**Johnson Creek Boulevard Traffic Meeting
February 11, 2010
Ardenwald Elementary**

Alan explained the History of Options slide - spanning three to four months.

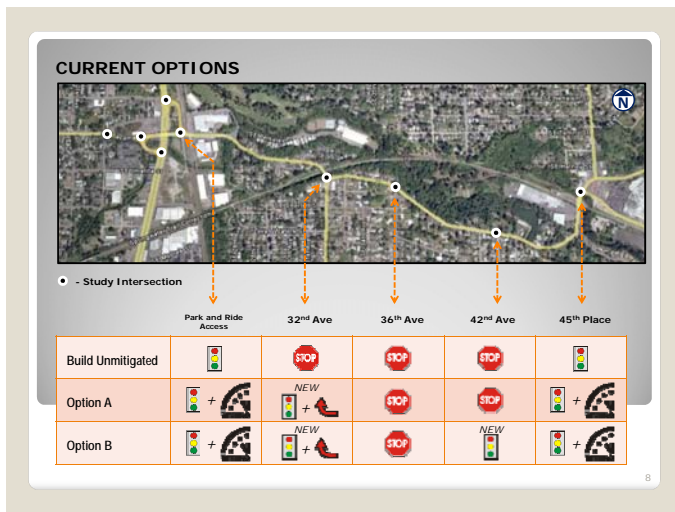
HISTORY OF OPTIONS					
	Park and Ride Access	32 nd Ave	36 th Ave	42 nd Ave	45 th Place
Existing					
Potential Option	+				+
Potential Option	+				+
Potential Option	+				+
Potential Option	+	+			+
Potential Option	+	+			+
Potential Option	+	+			+
